Subject: Exemption Request - Fire Protection Rule Scheduling Requirements
of 10 CFR 50.48(c)

Re: Vermont Yankee Nuclear Power Station

POST FIRE SHUTDOWN CAPABILITY

VERMONT YANKEE PLANT

Diagram 2A

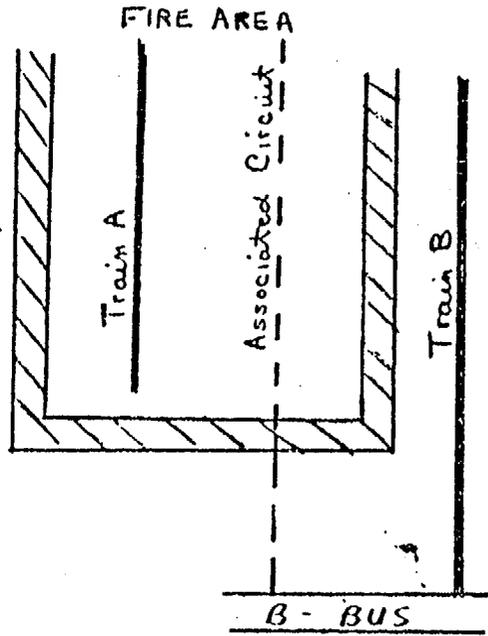
1. Have a physical separation less than that required by Section III.G.2 of Appendix R, and;
2. Have one of the following:
 - a. a common power source with the shutdown equipment (redundant or alternative) and the power source is not electrically protected from the circuit of concern by coordinated breakers, fuses, or similar devices (see diagram 2a), or

2. a. For a common power source case of associated circuit:

Provide load fuse/breaker (interrupting devices) to feeder fuse/breaker coordination to prevent loss of the redundant or alternative shutdown power source. To ensure that the following coordination criteria are met the following should apply:

Diagram 2B

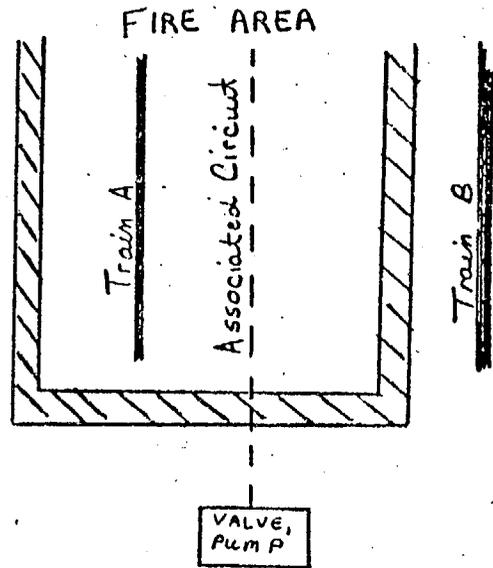
- b. a connection to circuits of equipment whose spurious operation would adversely affect the shutdown capability (e.g., RHR/RCS isolation valves, ADS valves, PORVs, steam generator atmospheric dump valves, instrumentation, steam bypass, etc.) (see diagram 2b), or

- b. For circuits of equipment and/or components whose spurious operation would affect the capability to safely shutdown:

- (1) provide a means to isolate the equipment and/or components from the fire area prior to the fire (i.e., remove power cables, open circuit breakers); or
- (2) provide electrical isolation that prevents spurious operation. Potential isolation devices include breakers, fuses, amplifiers, control switches, current XFRS, fiber optic couplers, relays and transducers; or
- (3) provide a means to detect spurious operations and then procedures to defeat the maloperation of equipment (i.e., closure of the block valve if PORV spuriously operates, opening of the breakers to remove spurious operation of safety injection);

Diagram 2C

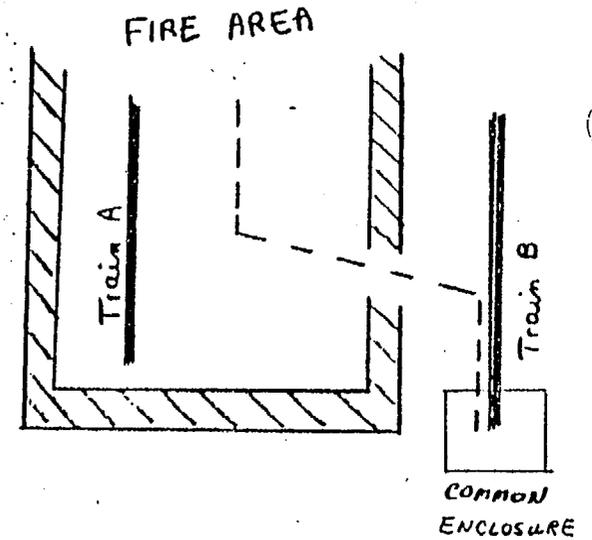
- c. a common enclosure (e.g., raceway, panel, junction) with the shutdown cables (redundant and alternative) and,
 - (1) are not electrically protected by circuit breakers, fuses or similar devices, or

- (2) will allow propagation of the fire into the common enclosure, (see diagram 2c).

c. For common enclosure cases of associated circuits:

- (1) provide appropriate measures to prevent propagation of the fire; and
- (2) provide electrical protection (i.e., breakers, fuses or similar devices)
